UNITED STATES PATENT AND TRADEMARK OFFICE

APPLICATION NO.	FILING DATE	FIRST NAMED INVENTOR	ATTORNEY DOCKET NO.	CONFIRMATION NO.
10/580,344	01/28/2008	Josef Ott	Q95051	5820

Office Action Summary	Application No. 10/580,344	Applicant(s) OTT, JOSEF	
	Examiner ROBERT E. FULLER	Art Unit 3676

DETAILED ACTION

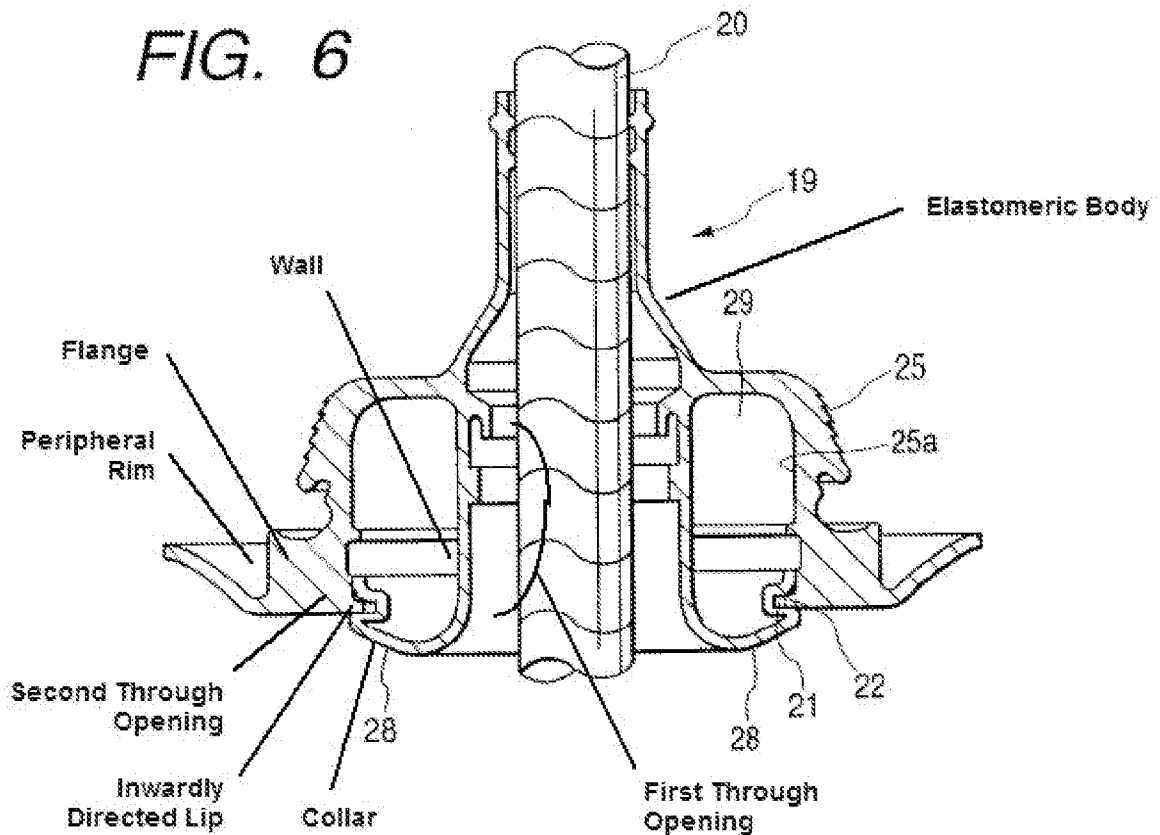
With regard to claims 1 and 3, as best understood by the examiner, Yamada et al. disclose the claimed seal in Figs. 4-6. See Figure below for a detailed explanation.

With regard to claim 7, the first opening actually begins at the curvature of the wall, proximate numeral 28. In that sense, the first opening can be considered to be above the second opening. In any case, the direction "above" is never positively defined in the claim with reference to any other part of the structure. Therefore, the first opening can be considered above or below the second opening.

With regard to claim 10, Yamada et al. disclose a face seal ring (i.e. the lip on the wall--see Figure above).

Examiner respectfully traverses. As can be seen in the Figure provided above, the first opening is at the front side of the seal, since the first opening starts at the curvature of the wall portion proximate numeral 28. The collar is also close to the first opening, as shown in the Figure. In any case, the terms "at" and "close to" are fairly broad. For example, the term "close to" certainly does not require the collar to be directly adjacent the first opening.
